ROADWAY BULLETIN

NCDOT Construction Unit

Current Issue: Thickness Requirements for Thermo

Volume 2, Issue 1 February 15, 2021

Portable Concrete Barrier in Work Zones

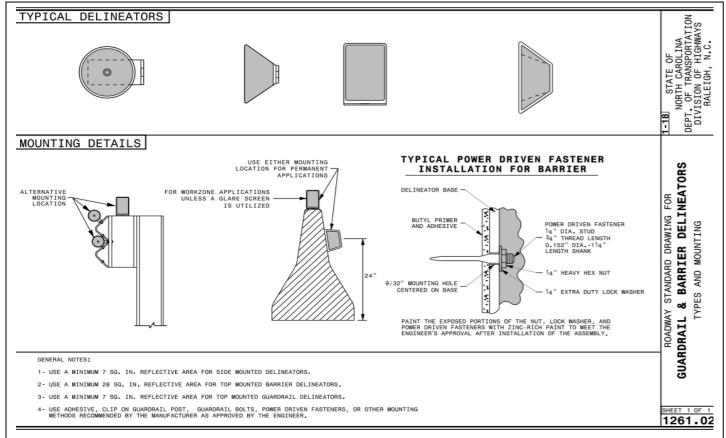
During recent reviews of work zones throughout the state, the Work Zone Traffic Control Unit has noticed a lack of delineators being used on portable concrete barrier. Roadway Standard Drawing 1261.02 details the acceptable delineators required for portable concrete barrier.
